Jacfin Horsley Park Industrial Estate Project Application
Concept Plan: 10_0129
Major Project: 10_0130

Re: Jacfin Horsley Park Industrial Estate Project Application

Concept Plan: 10_0129, Major Project: 10_0130

Attachment 3
- Project
10-0129

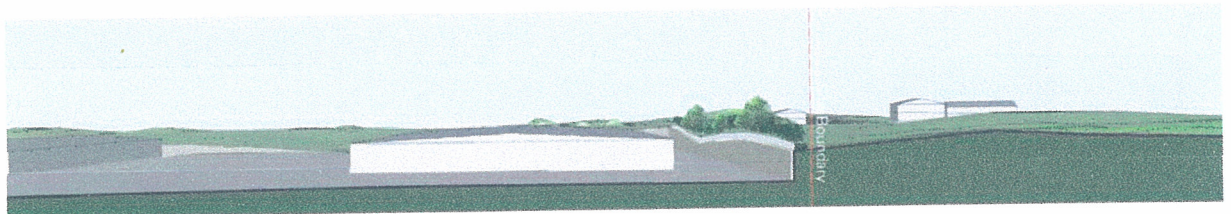
The cross-section diagram (Figure 17 of Appendix T of the EA) shows that the roof of the warehouse will be in line with the ground level of the adjoining property:

Whilst we haven't checked all levels in the street, the above certainly does not reflect the anticipated outcome for our own property. We have engaged a surveyor to identify the various relevant ground levels for our property and compare them to the VIA. (See Attachment 2 for the survey report.) The building pad of our house is RL91.6, whilst the lowest point of our rear

boundary (adjoining the Jacfin site) is RL 85. By studying the indicative cut and fill diagram provided in Appendix J2 to the EA, we can gather that the relevant ground level for the warehouses/factories to be located directly in front of our property is RL85. (However, the proposed building pads used to create the cross-section diagrams are not consistent with the Cut and Fill Diagrams provided.) This means that there will be minimal cut to the site in front of us and the full height of the building walls will be within our view. If we use the height of the first warehouse in project application 10_130, the estimated height is 14 metres, so this would bring the factory roof to a level of RL 99, which is higher than our house.

In order to achieve the outcome presented in JBA's document, the Developer would need to excavate 11-14 metres deep, outside our boundary. Notably, JBA are also stating in Section 6.11 of the EA, page 69, that the building pads will be "14-21 metres below the level of Greenway Place". Again, this doesn't make sense. At the front of our house, as shown in our Survey diagram, the crown of the road is RL 88.2, which would mean a building pad of RL 67 – 74, which is outside the range indicated in the Concept Plan.

- Require a maximum building pad level of RL 78 (or lower) and also limit building heights to 9 metres, in order to minimise the visual impact.
- Limit activity and operations to normal business hours, on weekdays and Saturdays.

CP009 Concept Plan

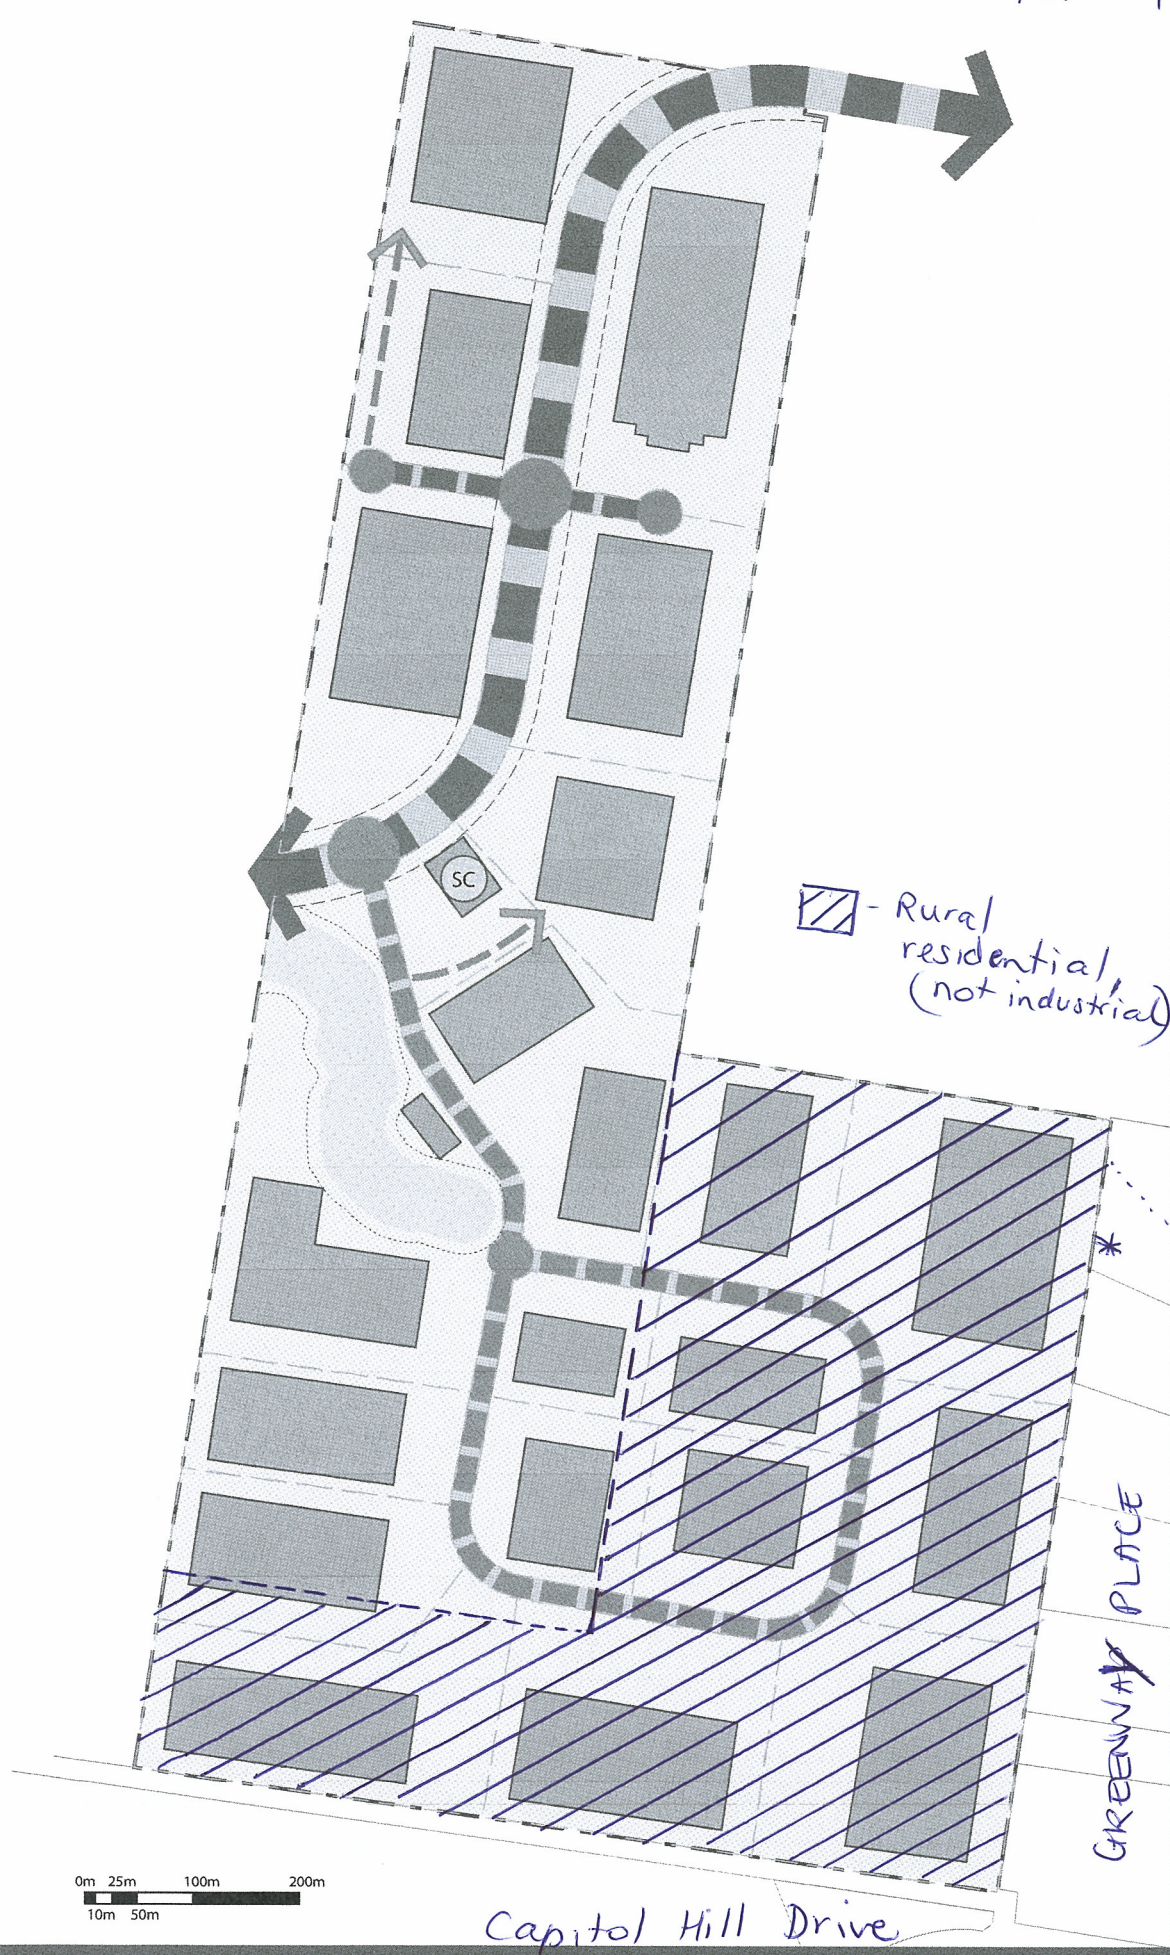
There should be a buffer zone between the factories/warehouses and the eastern and southern residential boundaries. The area in front of residents (marked on Attachment 1) should instead be utilised for rural residential blocks. This would provide a buffer to existing residents and would be consistent with the existing landscape, heights and character of the surrounding residential areas, as per Section 23 of the SEPP.

- Provide a buffer zone between the residential properties and the industrial estate, in line with the quarry boundary (as marked on Attachment 1). Consider using this land for rural residential subdivision, to minimise costs associated with open space for the landowner. These blocks could be sold with a caveat indicating that owners cannot object to future industrial buildings, provided that they comply with the relevant DCP and SEPP (WSEA) 2009.

Attachment 2.
- Theresa Patrick McCall
submission

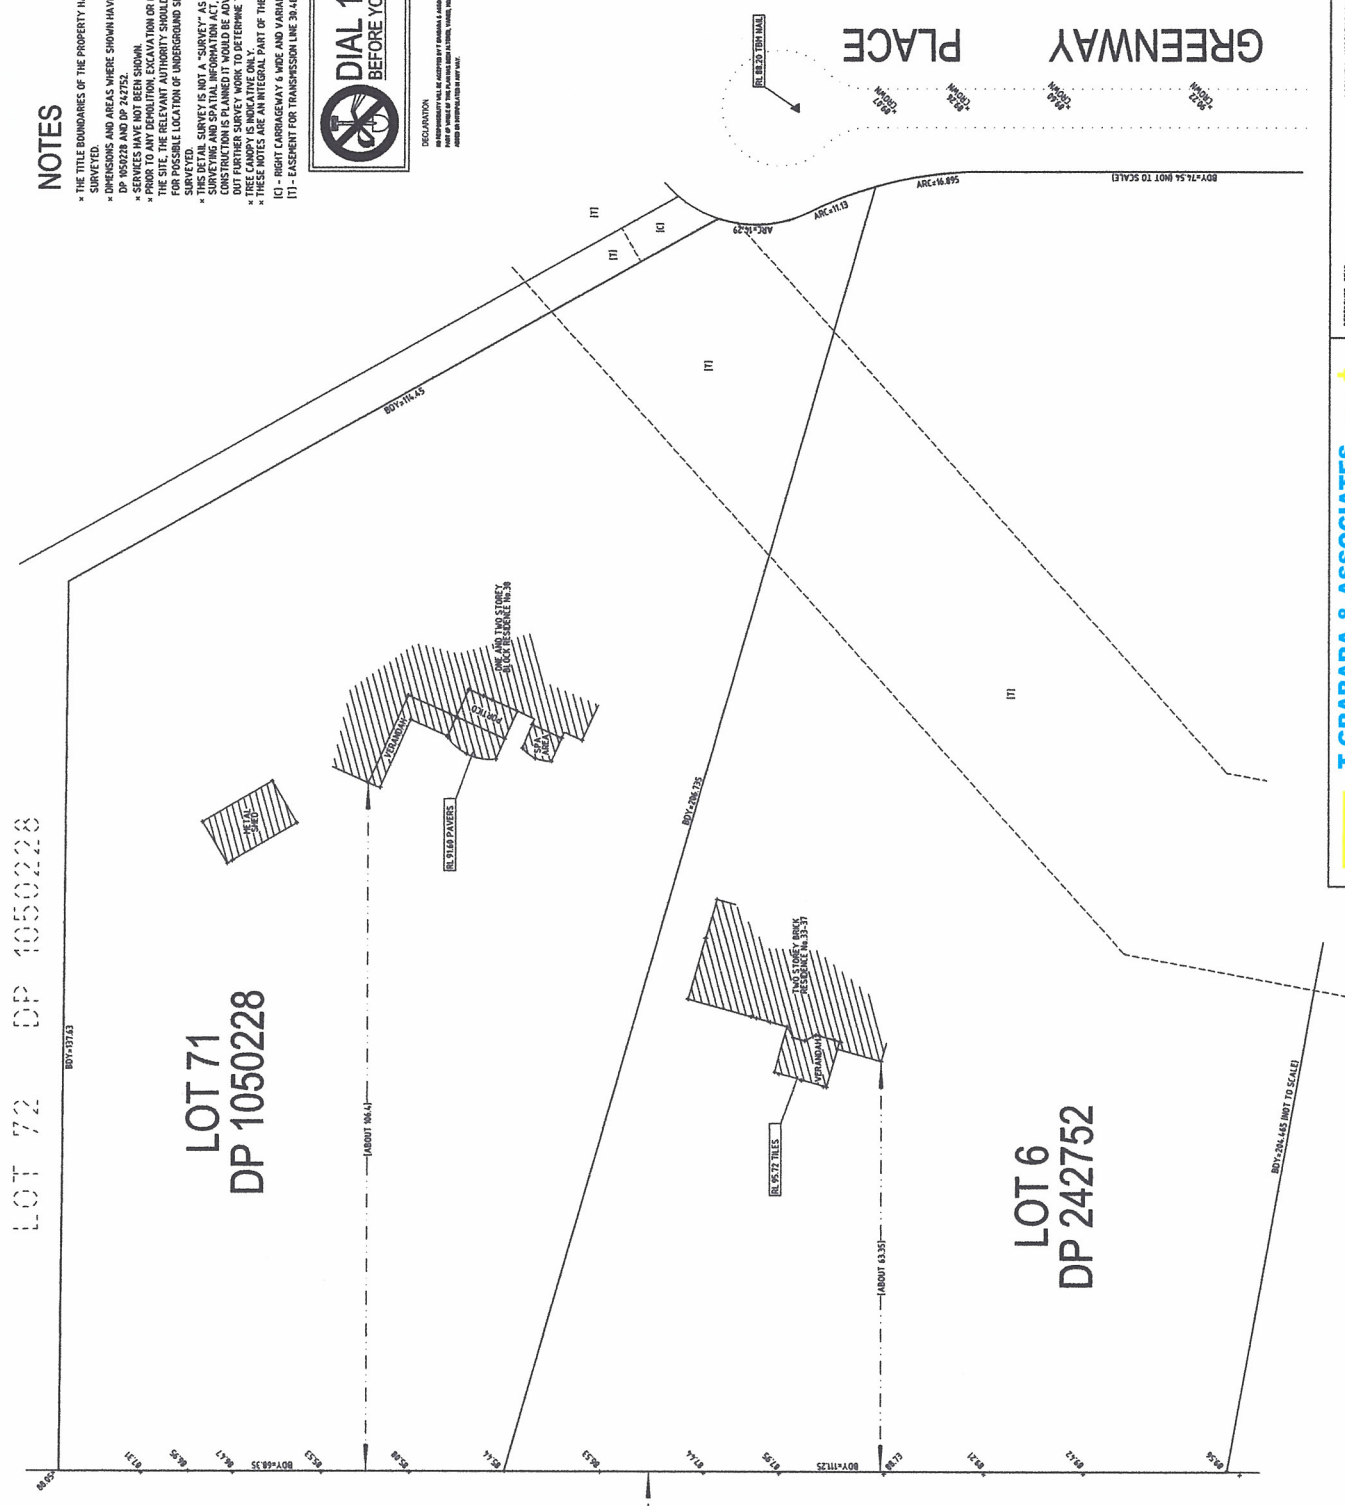
You will see both in the photograph below, and the survey diagram, that there is a green leafy tree directly in front of our neighbour's property and within our views to the southwest. This tree is approximately 14.6 metres high, based on our surveyor's measurements (taken from within our neighbour's boundary). The level at the top of the tree is approximately RL99.0. You can see in the photographs that this tree is much higher than the horizon and any buildings equivalent in height will **completely block our views**. **On this basis, we can state that the information provided in the proponent's VIA is misleading from the perspective of our property.** Perhaps the diagrams used in the EA may represent best case scenarios for one or two properties with the highest building pads in the street, however, it is certainly not the outcome for us. Ideally, the EA should provide a visual impact study for every adjoining property, considering the varying elevations of the properties.

The attached survey plan by T Grabara and Associates shows the floor levels of primary living areas of each of my clients' properties. As a guide to what the likely effect on their views will be, the location and height of a prominent residual ironbark tree in the subject land was also surveyed. The tree is visible in the photographs attached, which depict views from inside each property.

Plate 2
View southwest from the McHale residence
The scale tree is on the left side of the view

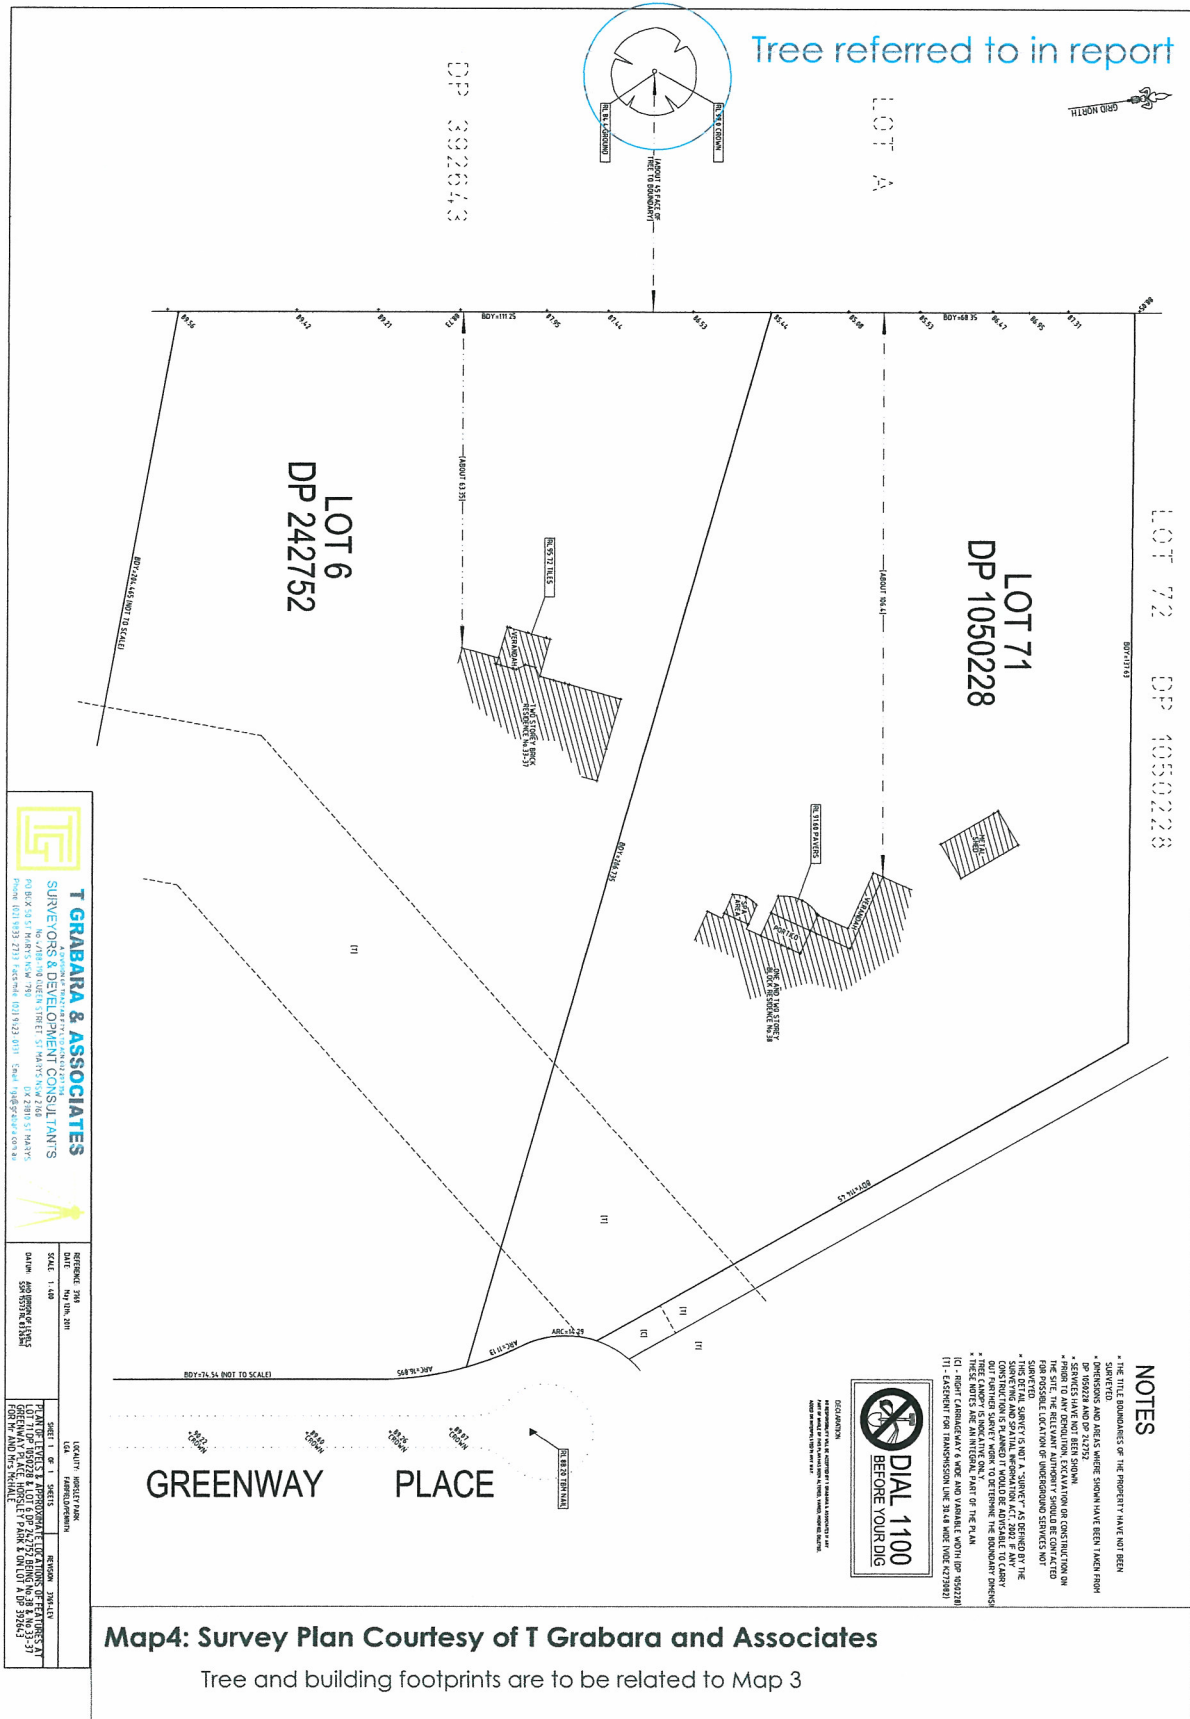
The photograph below shows the view looking directly forward from our back garden. Our property boundary is the last fence where you can see long grass. You can see the slight hill in the photograph, which actually appears quite close to our property, since there is so much
